CATHEDRAL ROCK CHURCH
Grading & Erosion Control Plans
Tract A, Struthers Ranch
Filing No. 2
El Paso County, Colorado

**CATHEDRAL ROCK CHURCH
TRACT A, STRUTHERS RANCH FILING NO. 2**

SITE GRADING AND
EROSION CONTROL PLAN

C1.1

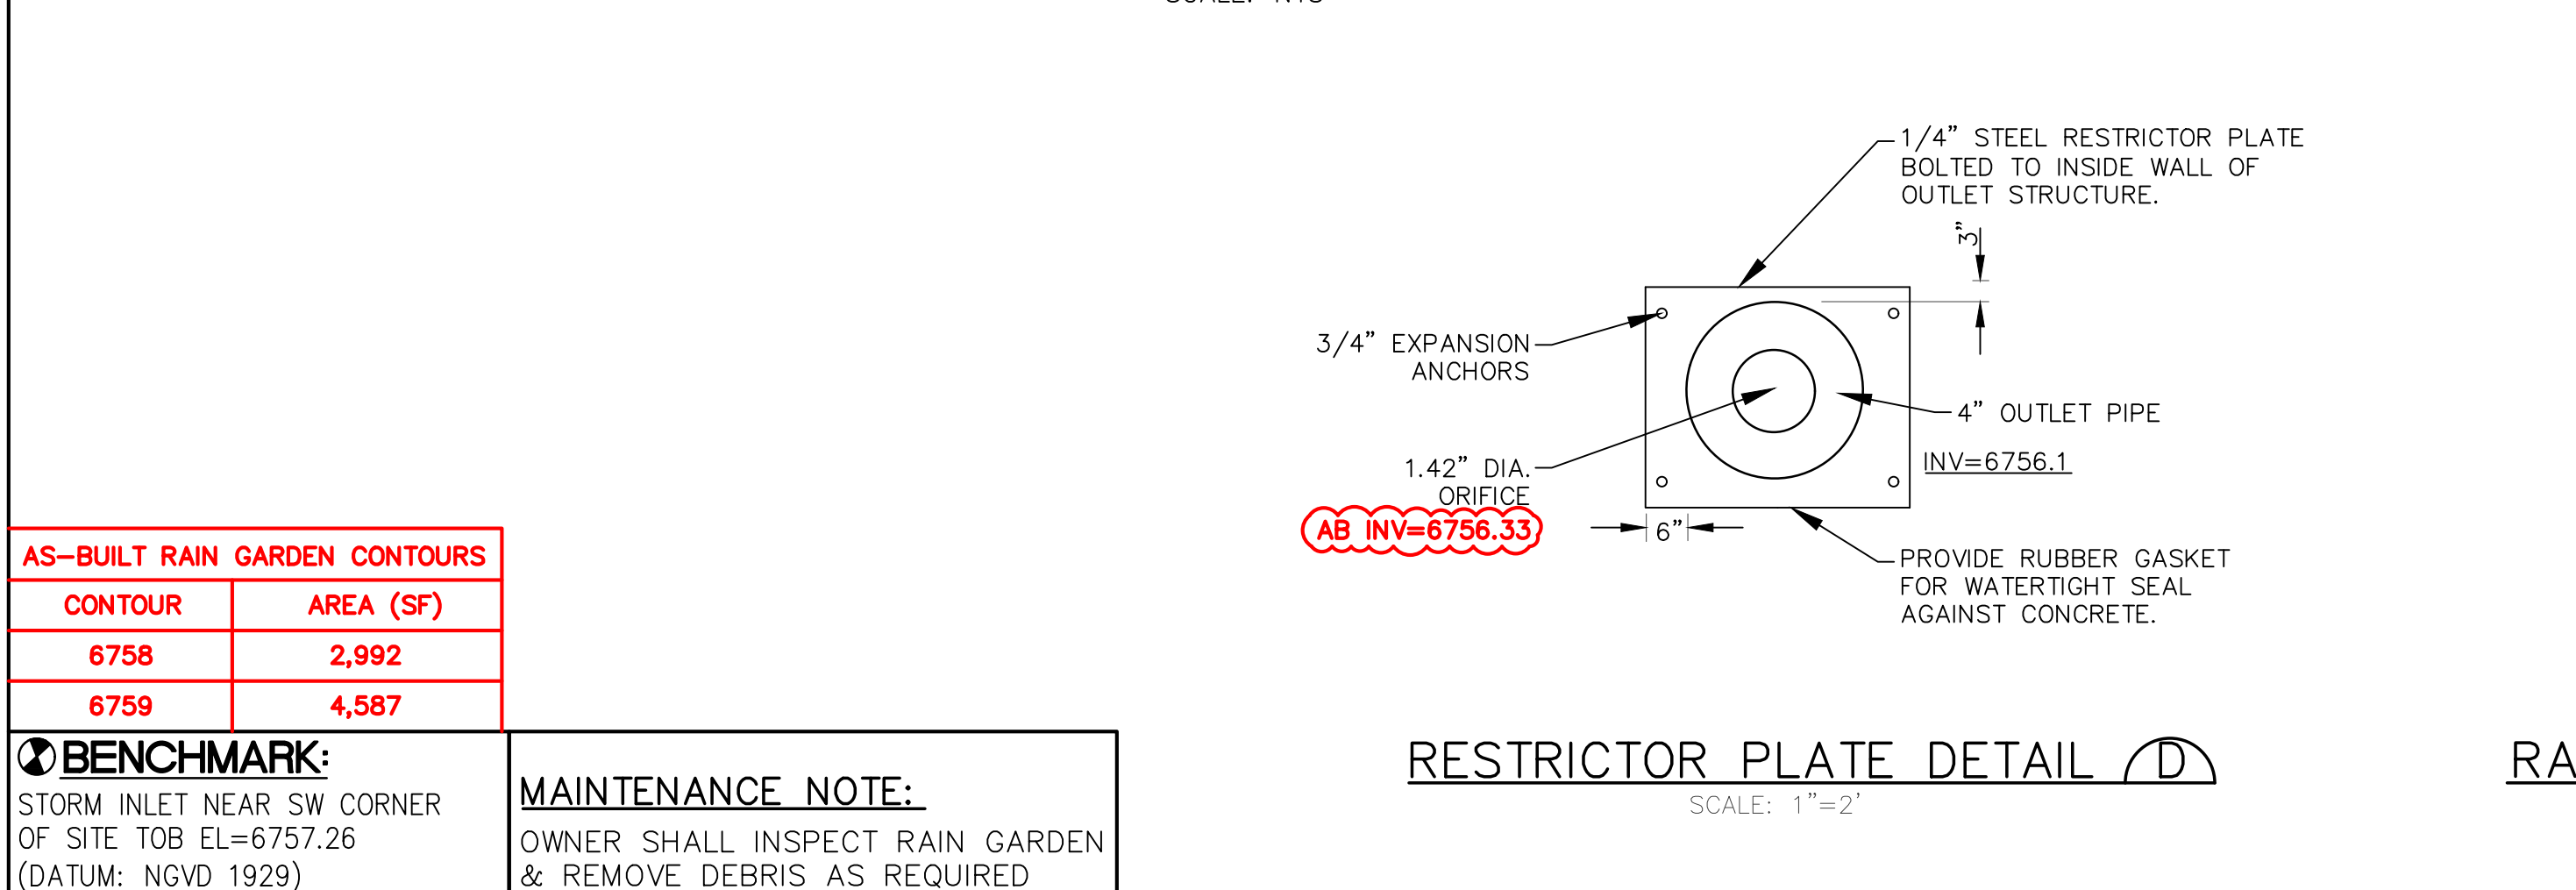
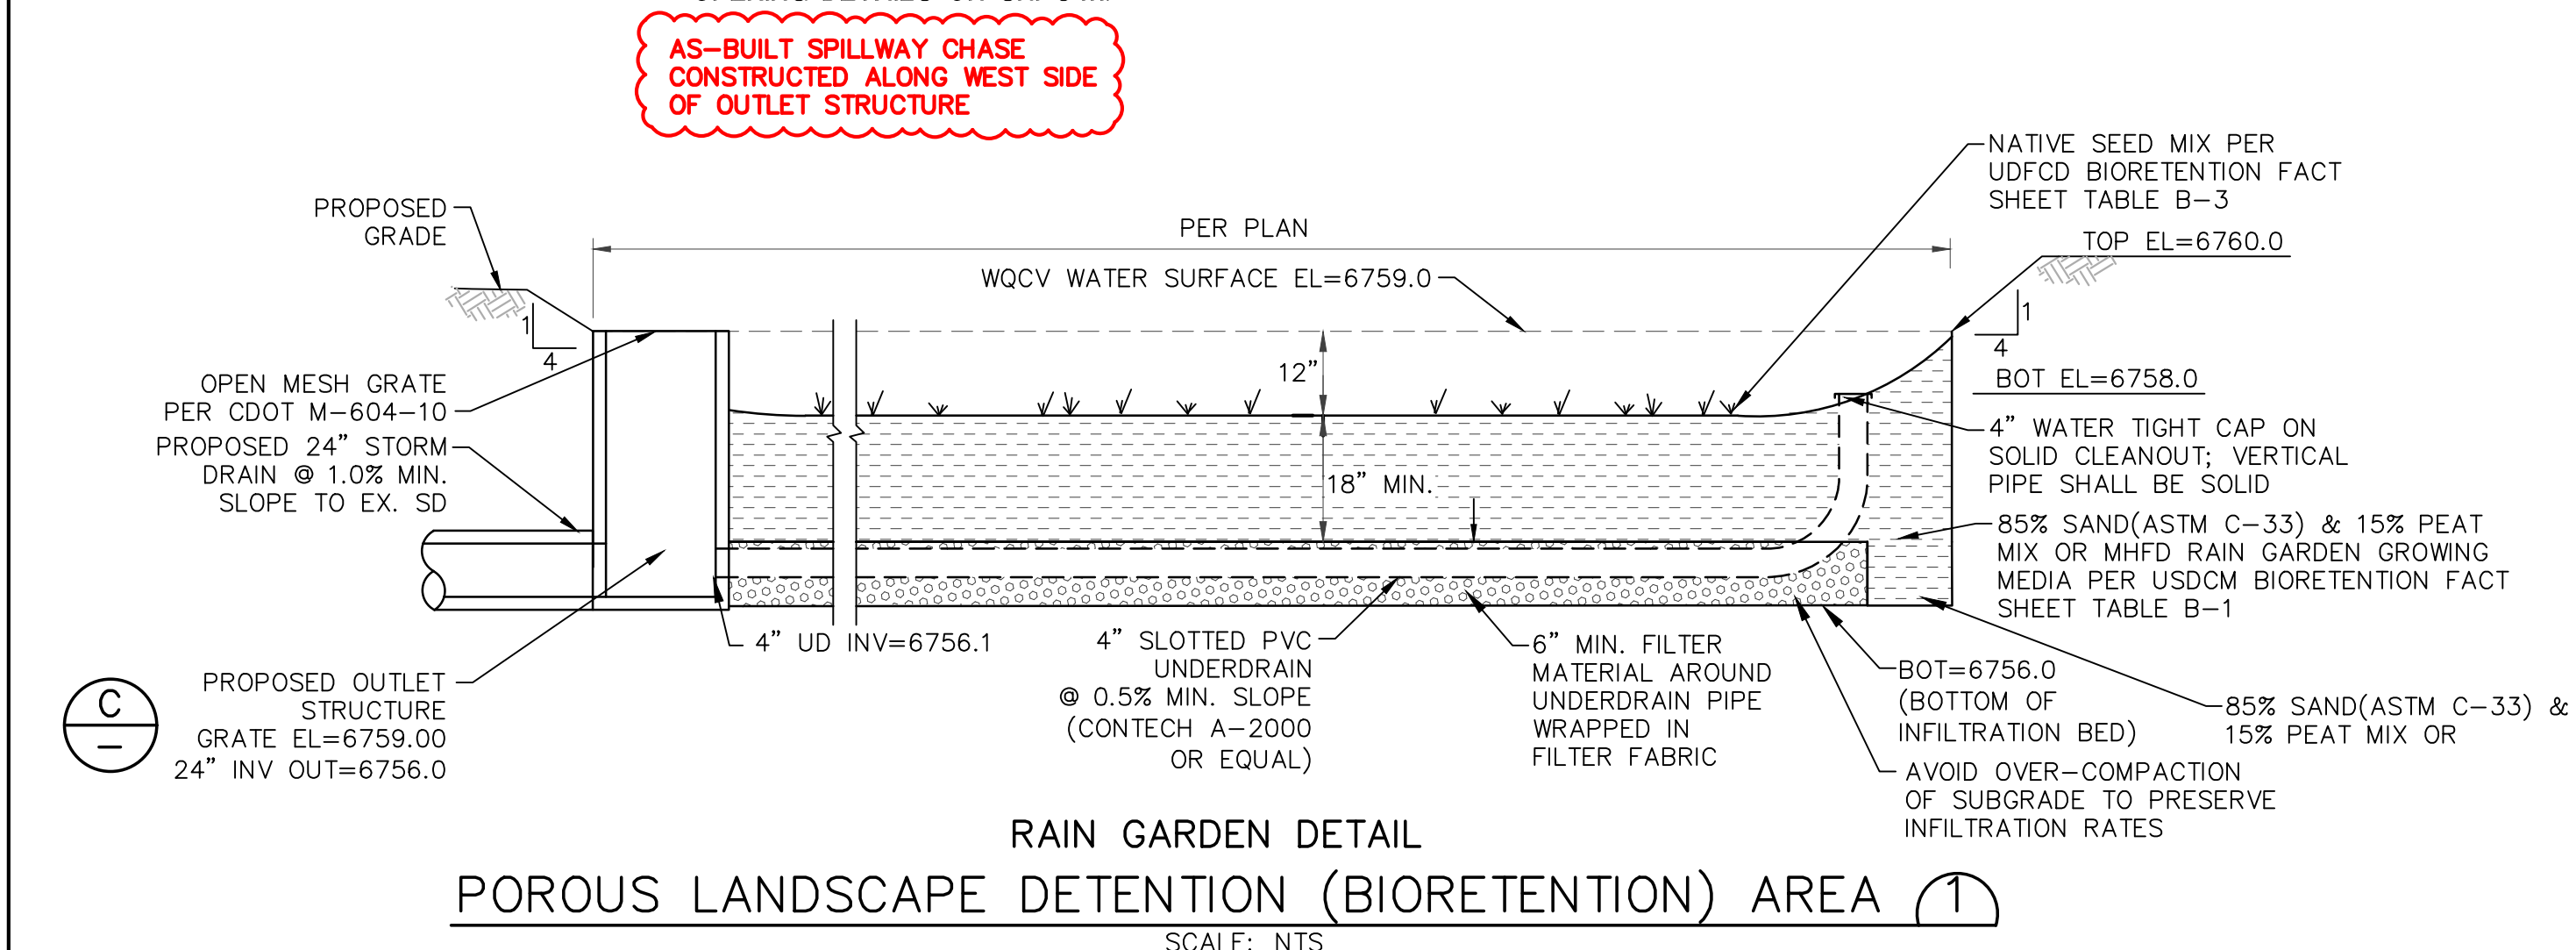
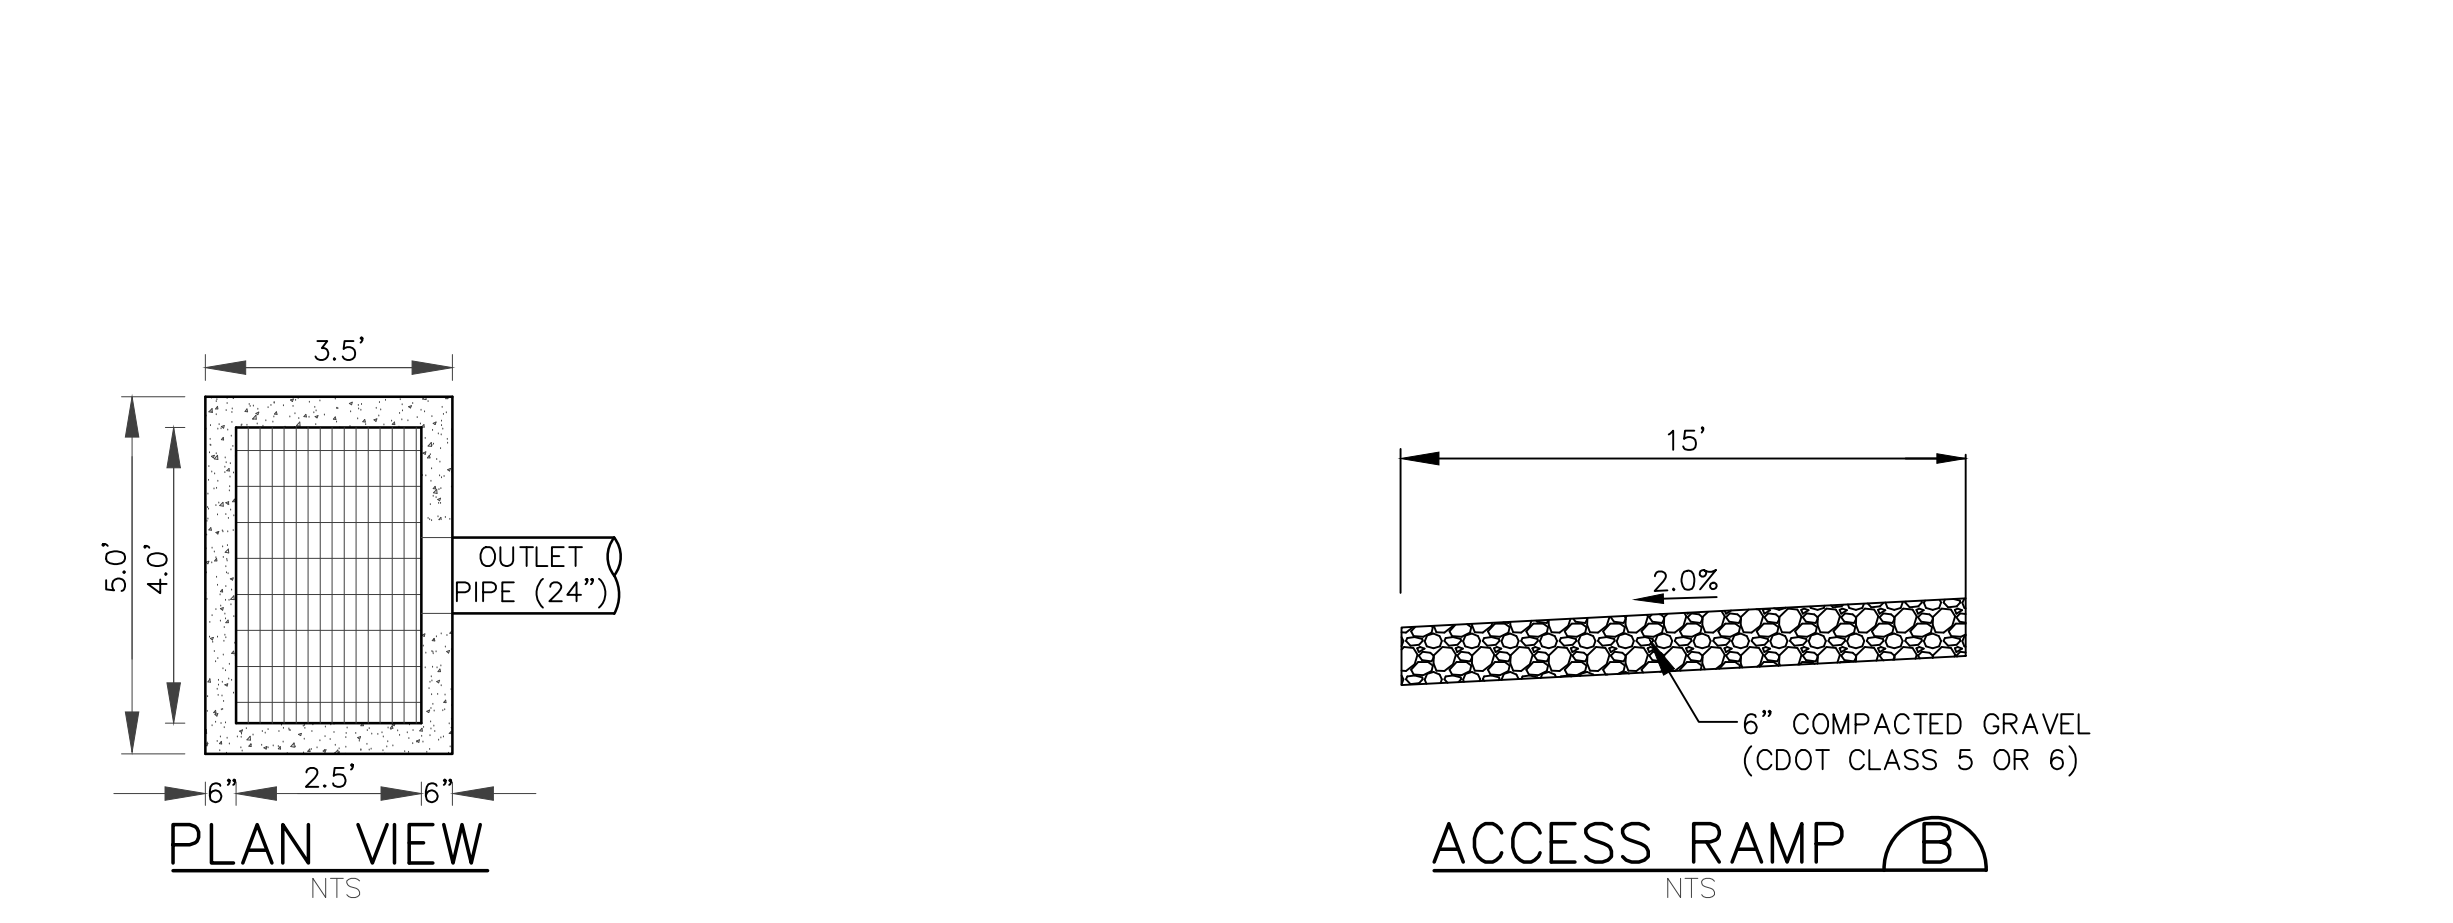
SW PA Punchlist finding:
"About 0.34 acres (~14,810 sq ft) of road base was installed where future building is proposed. This may affect the imperviousness of the site and may need alterations to the pond. Show deviation on as-builts. (Reference photos 9-10)."
ASB review comment: update the drainage/pond calcs and the as-builts accordingly.
